SILVER SPRING TRANSIT CENTER

Silver Spring Transit Center Structural Evaluation of Superstructure

March 15, 2013

RE: Silver Spring Transit Center
Above-Grade In Situ Structural (Project) Evaluation

FIGURE 1

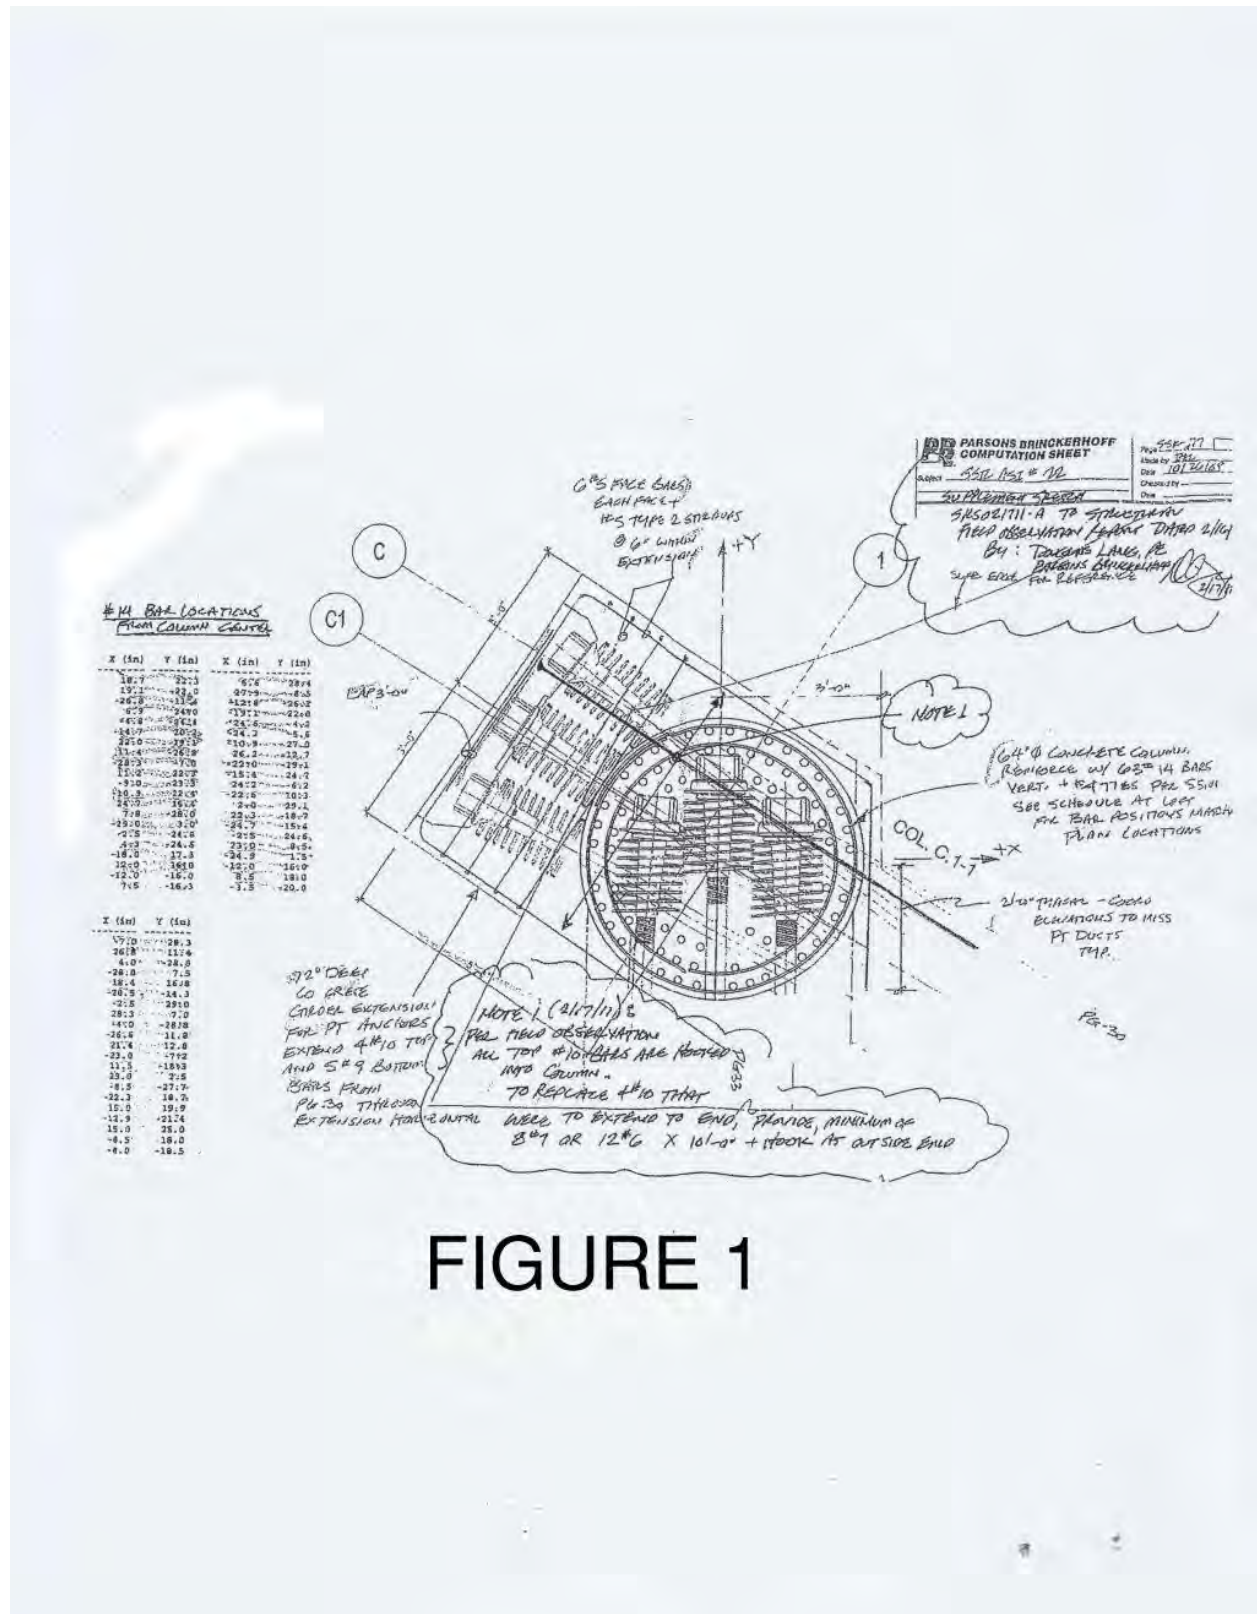
Column C7 above Levels 305 and above Level 330 appears to have two relocated bars on the North face of the column. We would note PB made numerous changes to column reinforcing locations to change the placement of the as-designed column vertical and lateral reinforcement to allow the placement of the as-designed deck post-tensioning (Figure 1), and this relocation was one of those changes.
